GeoShield Verification Report

PROJECT REFERENCE: GEO102875

PROJECT: Neath Port Talbot Hospital (Orthopaedic Unit).

REPORT NUMBER: 004

VERIFICATION LAYOUT

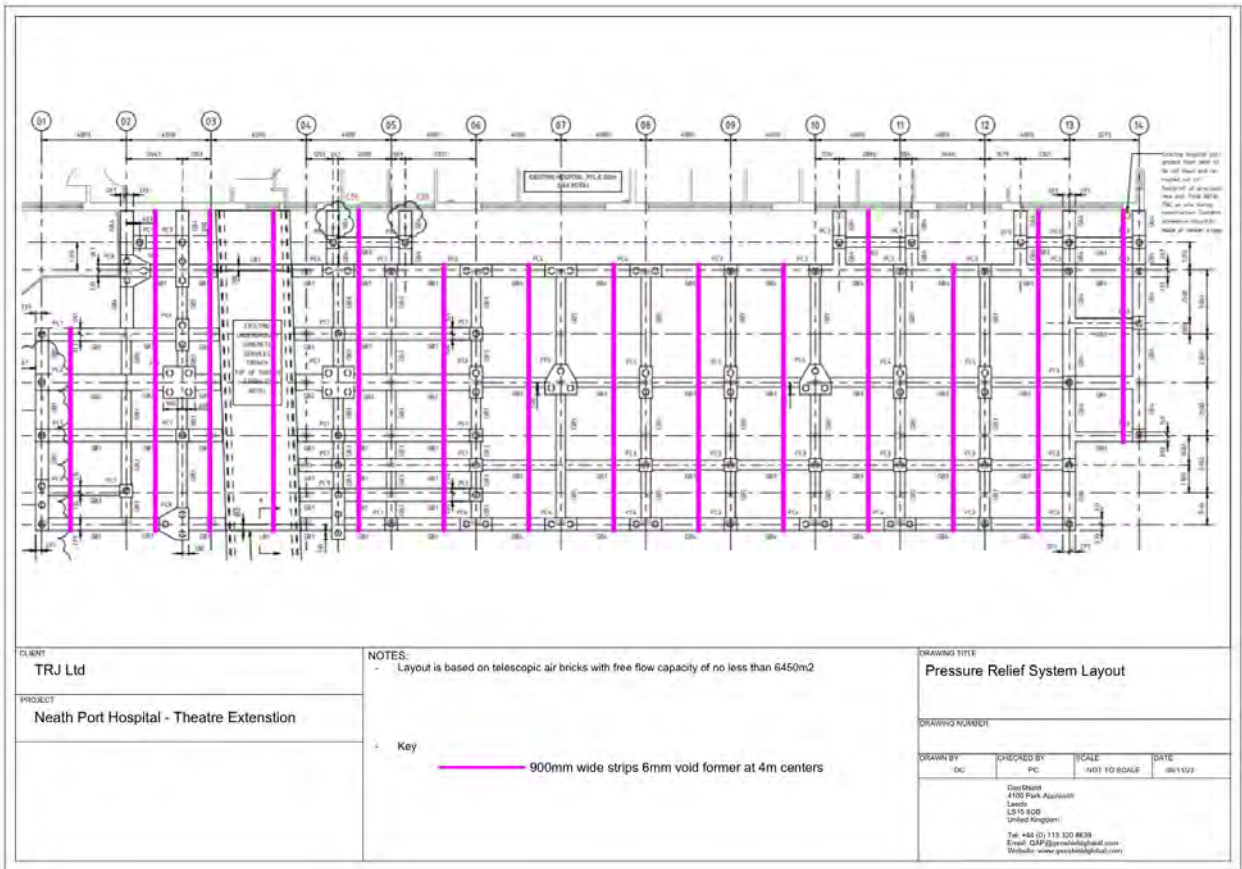
The layout above shows the site layout where the ground floor modules have been installed. Vents on opposite ends of pressure relief were verified during this visit.

VERIFICATION ITEM ONE

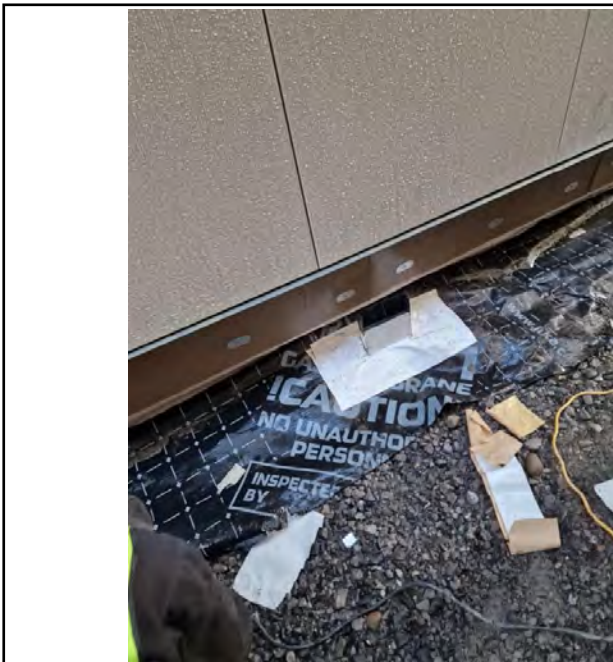
The periscope vents have been placed and sealed around the perimeter of the modular building. All vents have been placed on opposite ends of the FC6 Cuspate Geocomposite as per the design detail. The existing Juta GP1 gas membrane has been cut tightly...

...around each periscope vent prior to being sealed. The photograph on the left displays a sealed periscope vent and on the right displays evidence of the vent upon the vent mat.
